Product Change Notification: E-20-010055

PCN Date: 15-JUL-20

HVA 630 5P Connector

Picture:

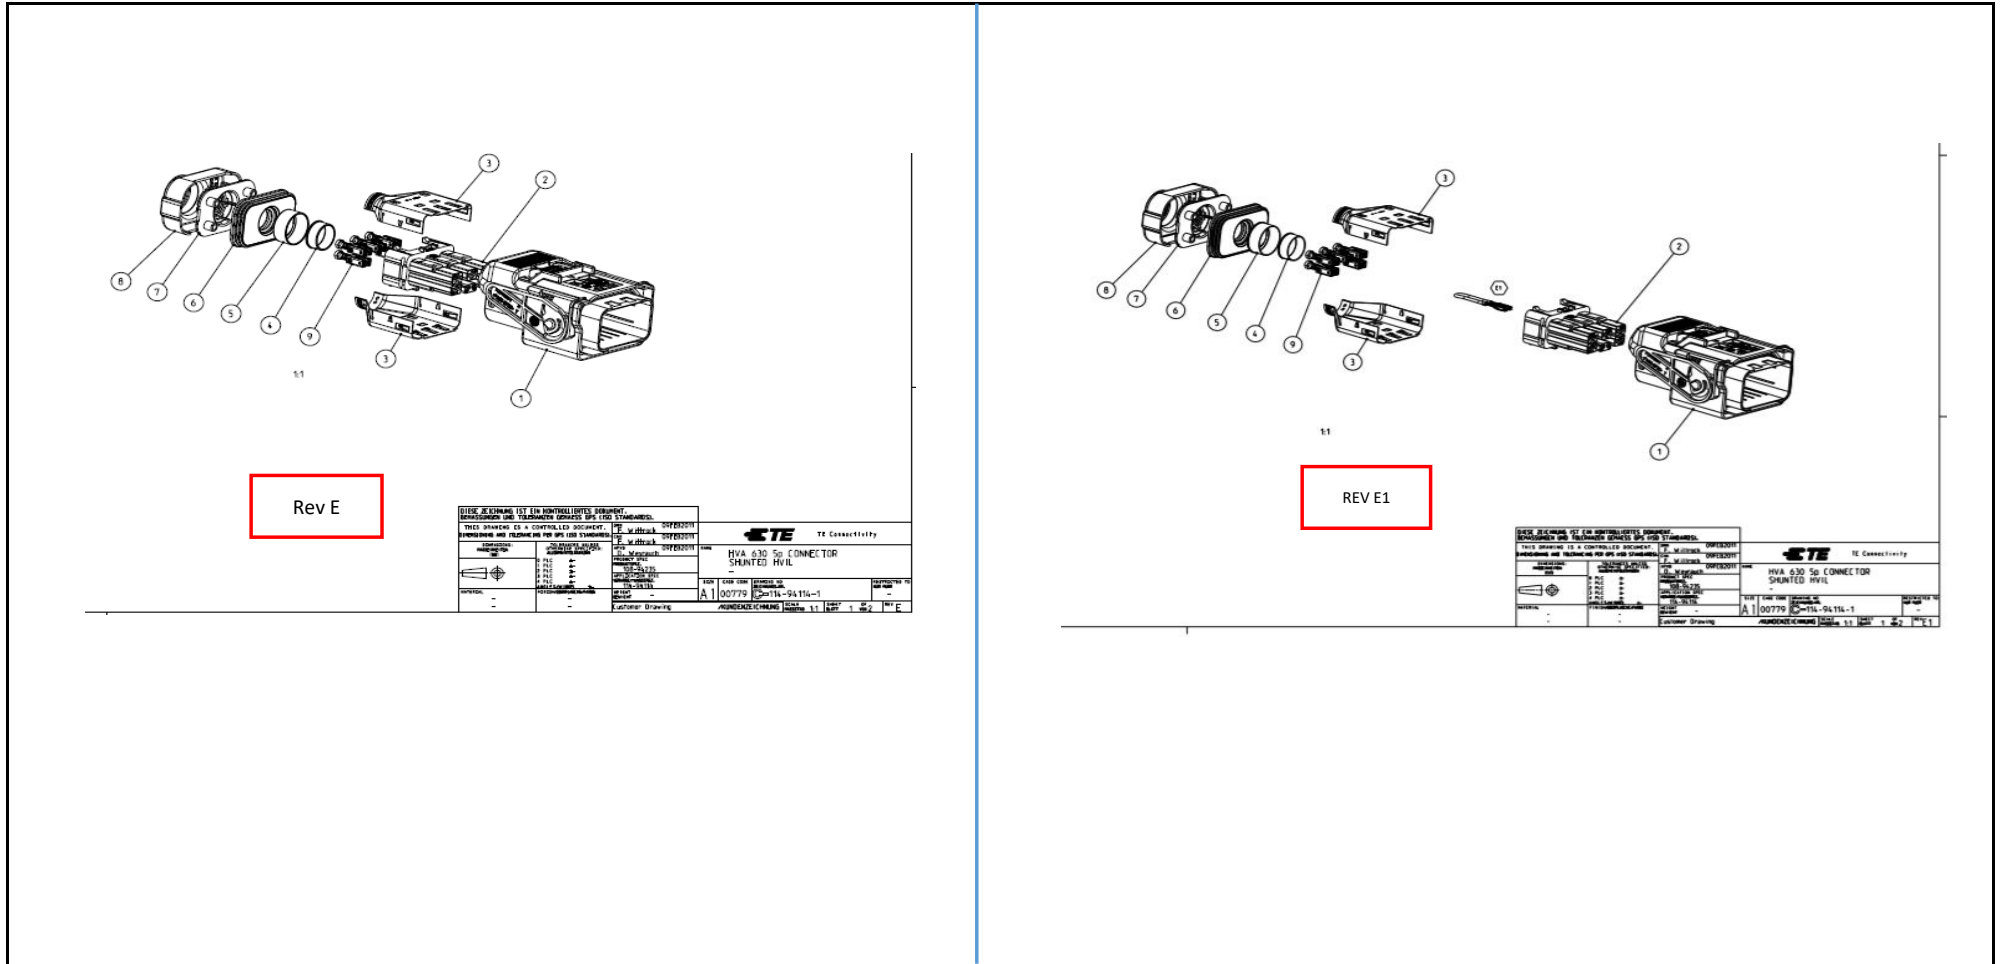
x	Potential Impact for Customer	x	Product Type	x	Change Type	x	Kind of Change	x	Change Feature	Remark / Free text
x	Revision adapted	x	HEMS PRODUCTS	x	No Form, Fit, Function	x	Drawing	x	Drawing Change	HVIL Contacts added in exploded view
